Lot 37
 Plan 2
 Parcel: 3414203003
 Elevation: Craftsman
 Crawl-Space
 Master Plan#: M153729
 Model: M1002

PLOT PLAN

444 GARDEN PARK AVE. CALHAN, CO 80808
 MAYBERRY, COLORADO SPRINGS FILING NO. 1
 A PORTION OF SECTION 14 & 15, T 14S, R 63 W, 6TH PM
 COLORADO SPRINGS, EL PASO COUNTY, COLORADO

DISAPPROVED
 Plan Review

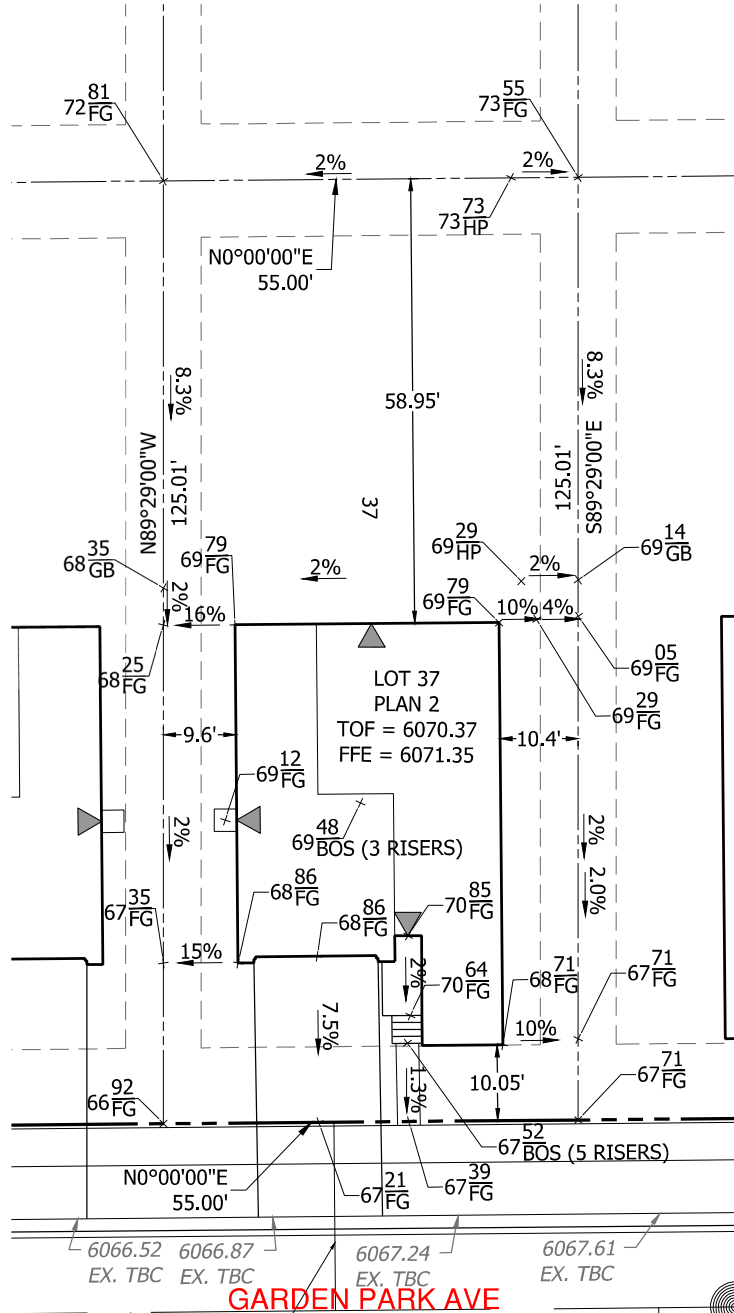
Provide site data (lot size,
 residence size, % lot
 coverage and average
 building height) on all site
 plans.
